## **COMMITTEE OF THE WHOLE DECEMBER 9, 2002**

### **ZONING BY-LAW AMENDMENT FILE Z.01.044 SITE DEVELOPMENT FILE DA.01.071 M. AND B. NICOLINI**

THAT Zoning Amendment Application Z.01.044 and Site Development Application DA.01.071 (M. and B. Nicolini) BE REFUSED.

# Elevation Plan

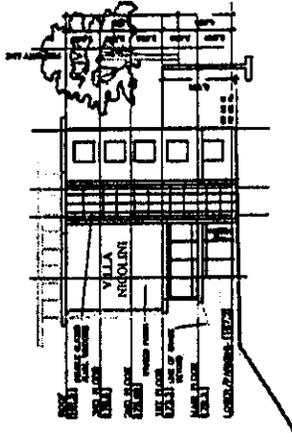
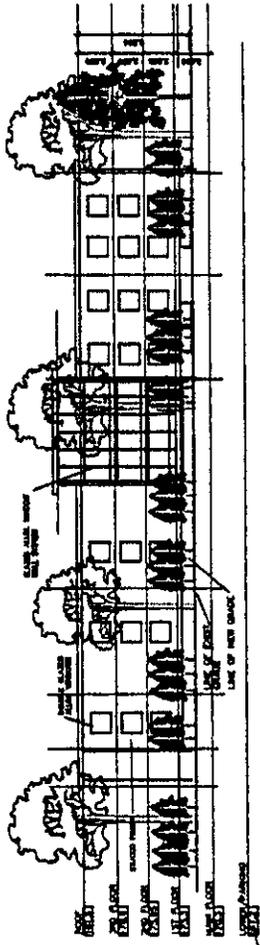
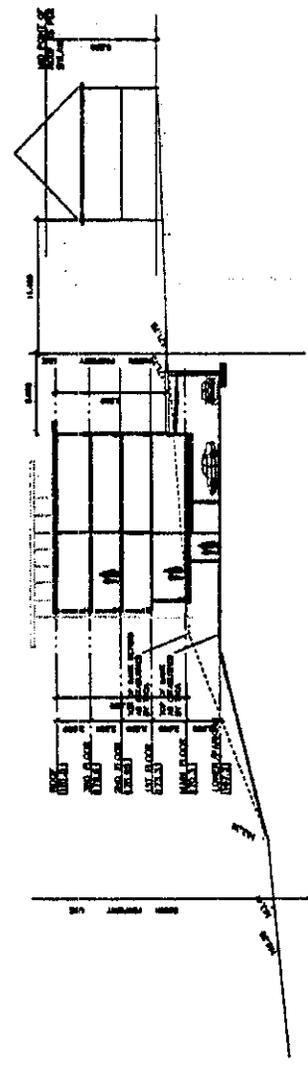
- adjacent homeowners expecting detached homes conforming to the R1 Zone are now presented with a three-storey wall, spanning 60 metres, at a setback of 5 metres; shifting the building to the south is restricted by the top-of-bank.

The proposed building ranges in height from 3½-storeys along the north, west and portions of the south elevations, to 5-storeys along the east and portions of the south elevations. The building is to be finished in stucco, with double-glazed aluminum windows on all elevations. The elevation plans submitted do not indicate any colour details.

**LOWER FLOOR/PARKING LEVEL PLAN**  
SCALE 1/4" = 1'-0"

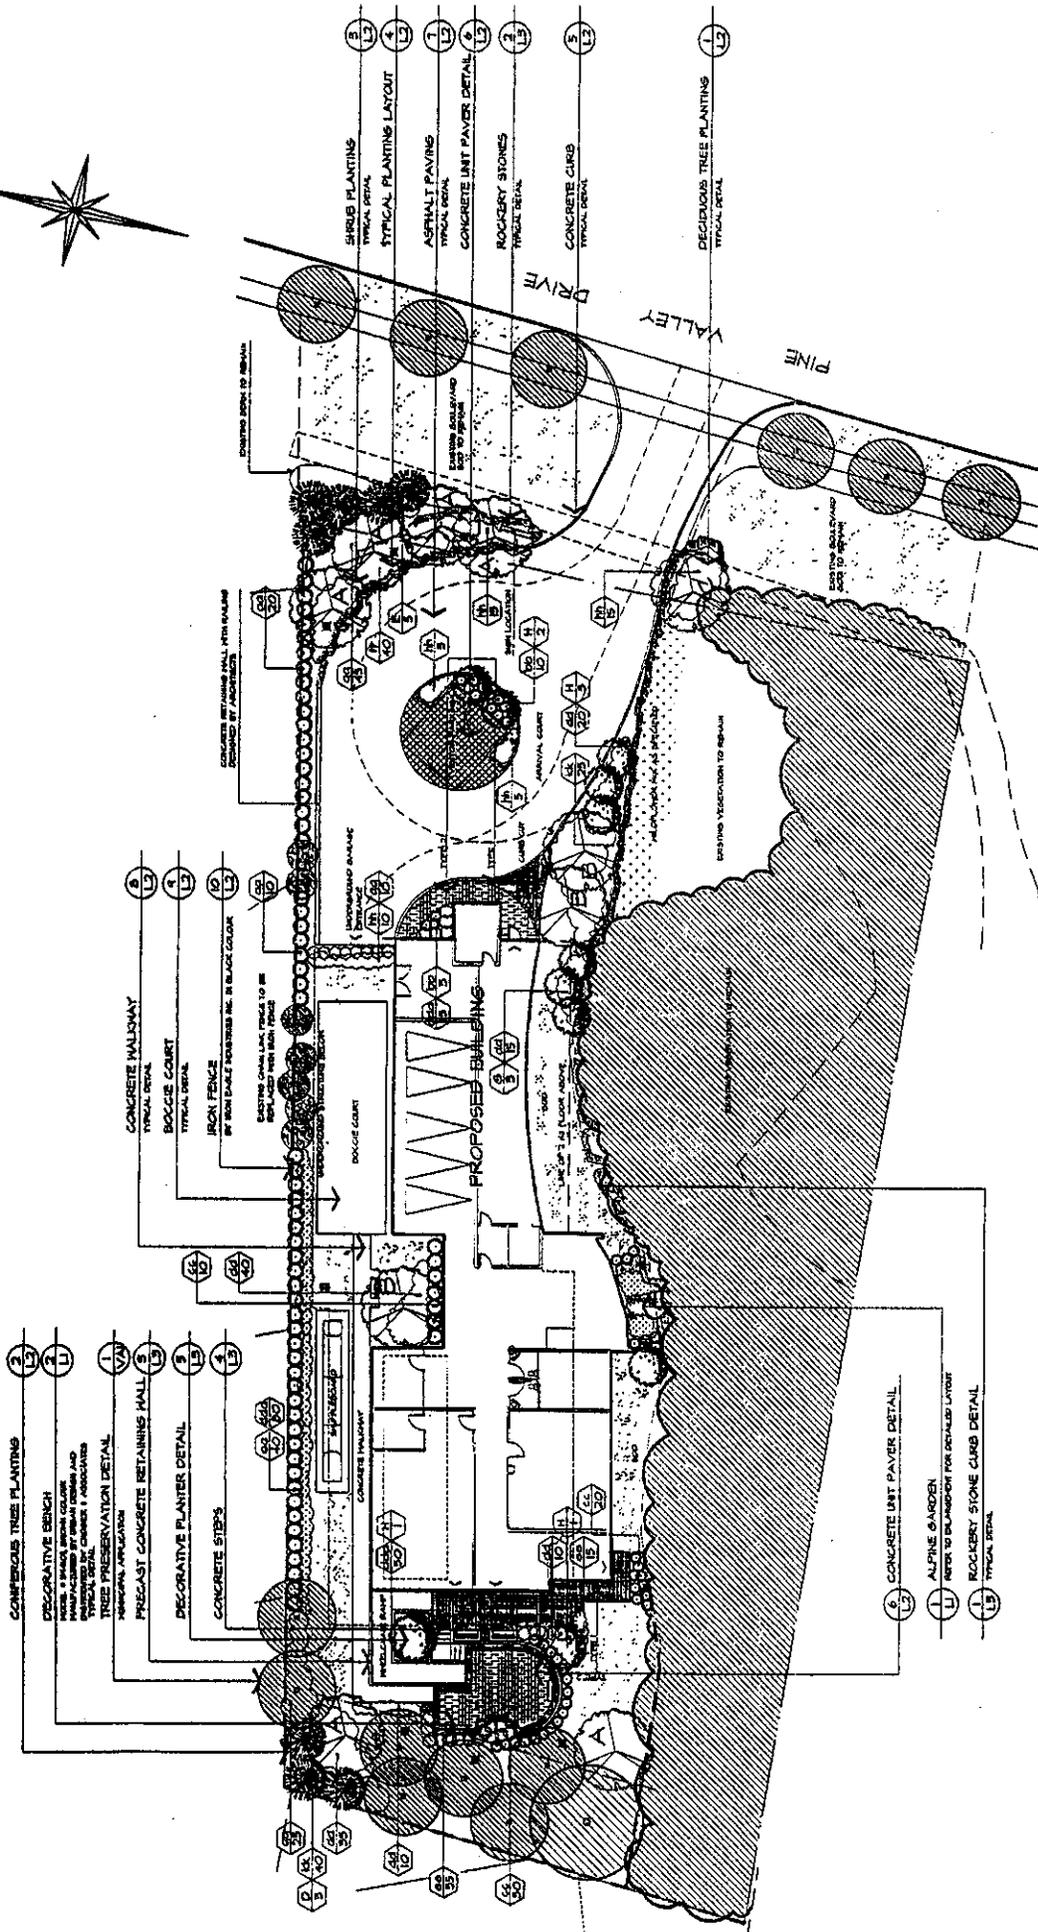
- Provide dimensions of parking spaces above and below grade, 2.7m x 6.0m typical (show dimensions between walls and pillars) and 3.9m X 6.0m handicapped spaces.
- Aisle width within underground parking area is less than 6m width, all aisle paths to and from a parking space shall be 6m minimum.
